MANUAL CHANGES

Model Number: 8445B

Date Printed: May 1973

Part Number: 08445-90103

Figure 1. Partial Schematic of Figure 8-10

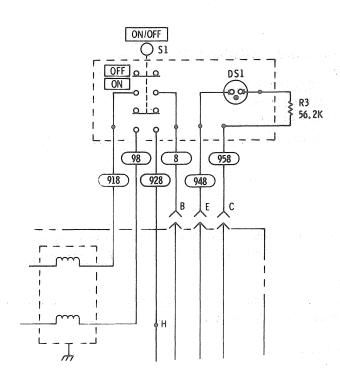
Page 8-23, Figure 8-10 (Service Sheet 6):

Change the diagram as shown in the partial schematic of Figure 1.

Figure 2. Partial Schematic of Figure 8-9.

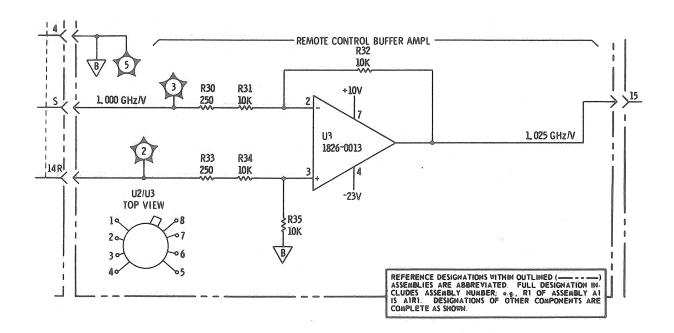
Page 8-9, Figure 8-21 (Service Sheet 5):

Change the circuit diagram as shown in the partial schematic Figure 2.

Figure~3.~~Partial~Schematic~of~Figure~8-8.

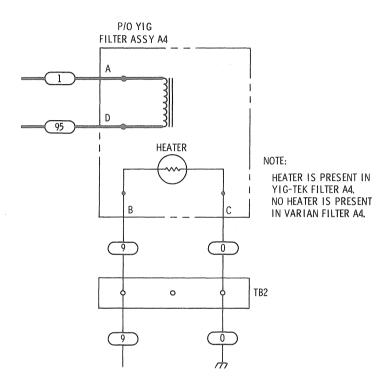
Page 8-19, Figure 8-8 (Service Sheet 4)

Add terminal strip TB2 as shown in partial schematic Figure 3.
